**City of Wasilla  
Ordinance Serial No. 22-27**

**An Ordinance Of The Wasilla City Council Amending The Fiscal Year 2023 Budget By Appropriating \$8,500 From The General Fund, Fund Balance And Transferring The Funds In The Amount Of \$8,500 To The CIP Fund For The MATCOM Generator Replacement Project.**

# Change Order

Re: Change Order CO-0001 for: Wasilla Old Police Building Generator Replacement

Sheet Title	ENLARGED SITE PLAN - DEMO & REVISED
Sheet Number	E200

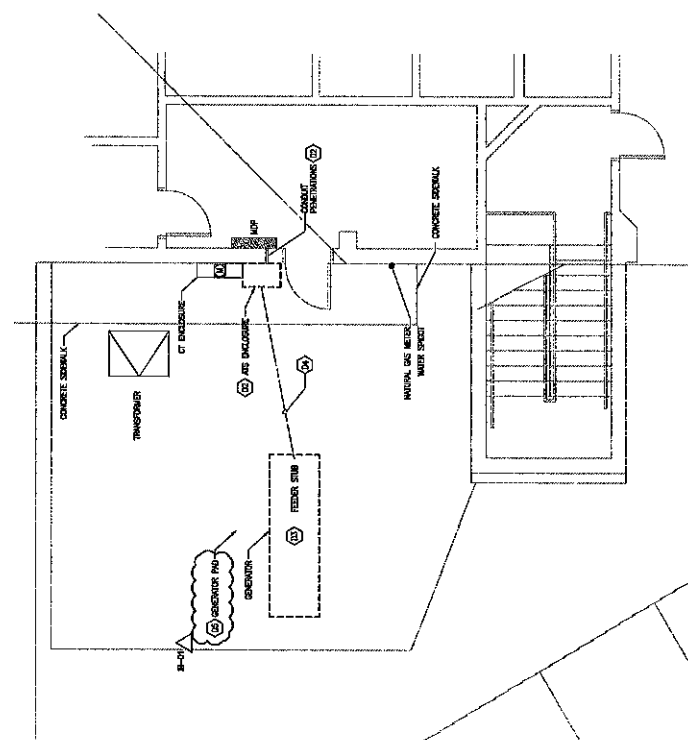
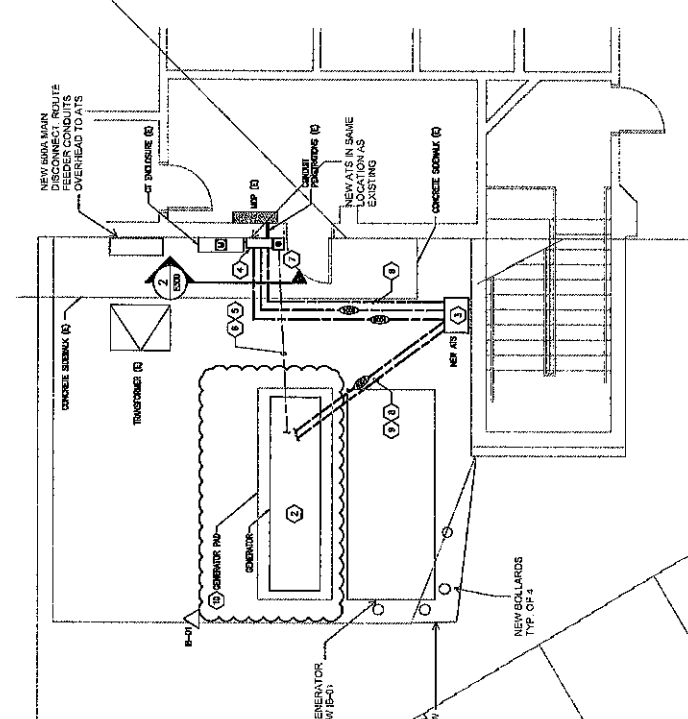
1. Demolish existing generator set equipment pad and provide new pad in accordance with revised Sheet E200.
2. Add generator equipment pad details 3, 4, and 5 in accordance with revised Sheet E300

1. E200 Reconfigure site plan to indicated addition of manual transfer switch (MTS) and portable generator connection block.
2. E300 Reconfigure partial power one-line and elevation detail to indicated addition of MTS and portable generator connection block.
3. E400 New sheet added. Relocated generator pad detail from E300 to this sheet. Additional detail provided for bollard.
4. Revised Drawings with IB-02
